Re: Children's Treatment Center, 6611 Gulton Court NE
Permanent Certificate of Occupancy – Transportation Development
Administrative Amendment to DRB Site Plan Project 1007974 (E17-D025)
Certification dated 05-11-11

Re: Certification Submittal for a Permanent Building Certificate of
Occupancy (C.O.) for **Children's Treatment Center**, [E-17 / D025]
6621 Gulton Court NE
Architect's Stamp Dated 05/05/11

Re: CTC Office, 6611 Gulton Ct. NE,
Request for 90-Day Temporary C.O.—Approved
Engineer's Stamp dated: 11/19/09 (E-17/D025)
Certification dated: 04-20-11

**Re: Children's Treatment Center Office Addition Grading and Drainage Plan
Engineer's Stamp dated 11-19-09 (E17/D025)**

6611 GULTON CT. SITE PLAN

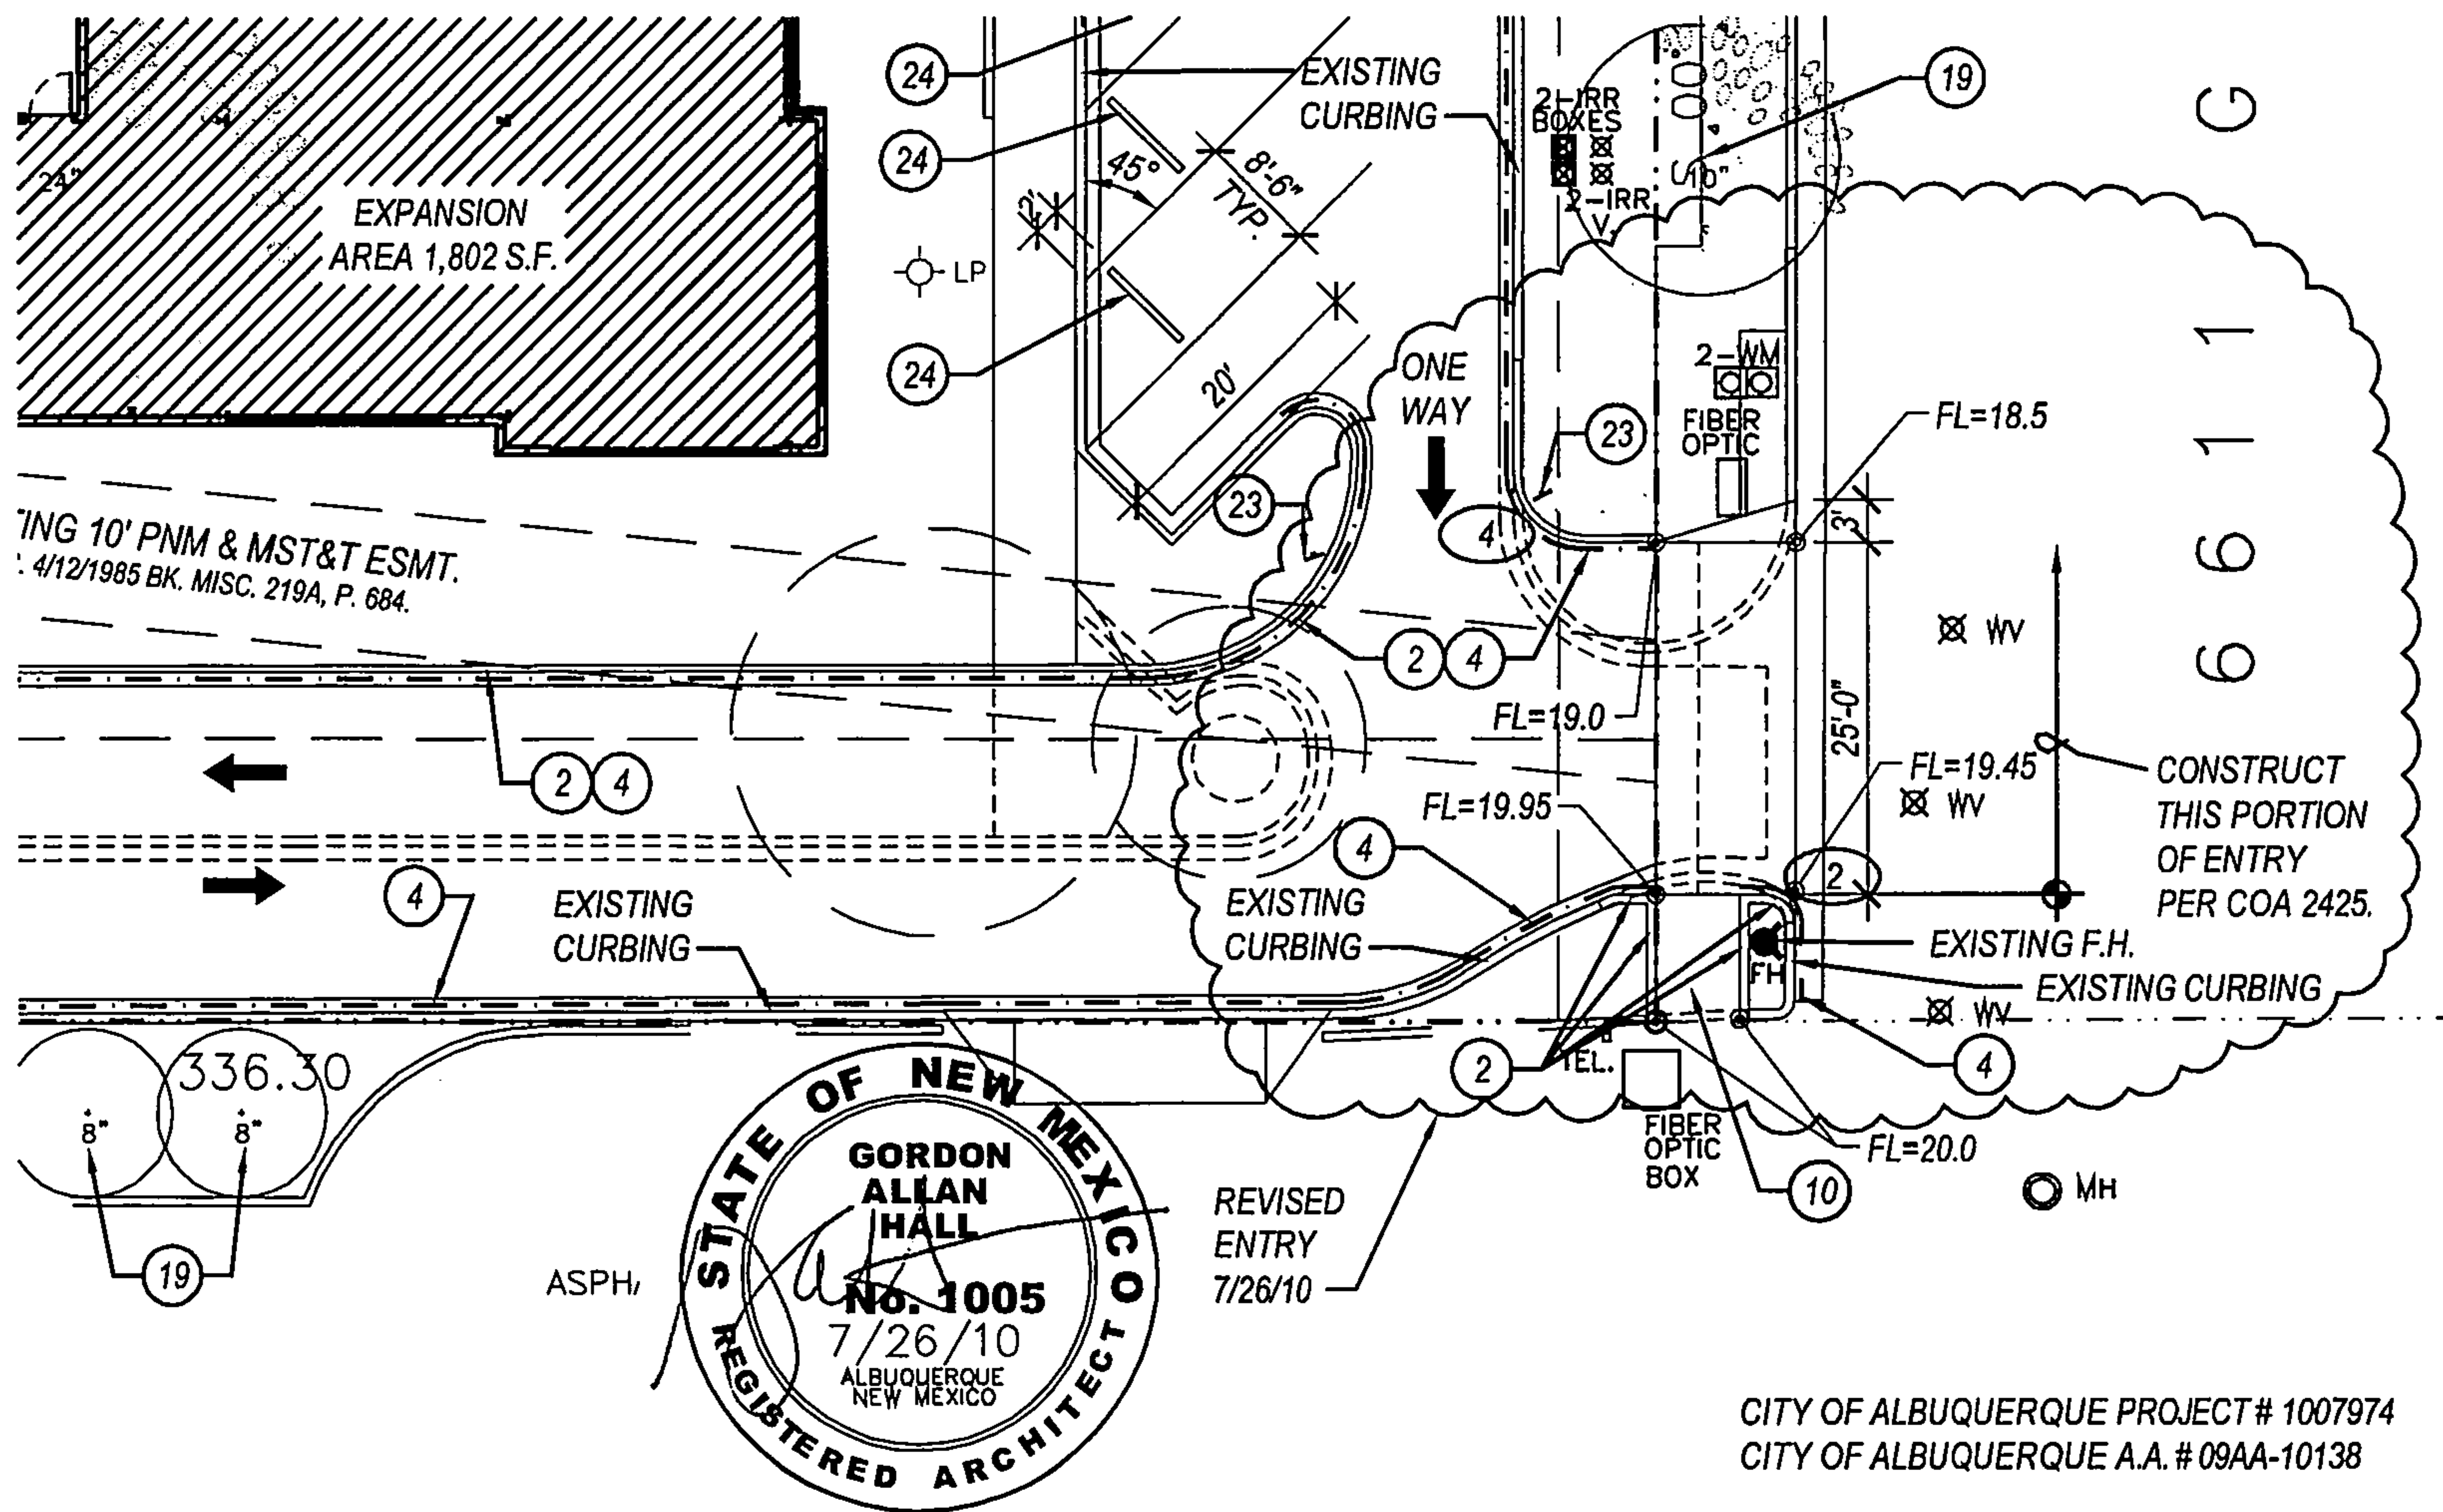
I, Gordon Allan Hall, do hereby certify that this project was constructed in substantial compliance with the Administrative Amendment approved on 10/13/09 and the revised entry plan dated 7/26/10. The revised entry plan was approved by Kristal Metro on 8/4/10 via Email. I am requesting a final Certificate of Occupancy for the project indicated above.
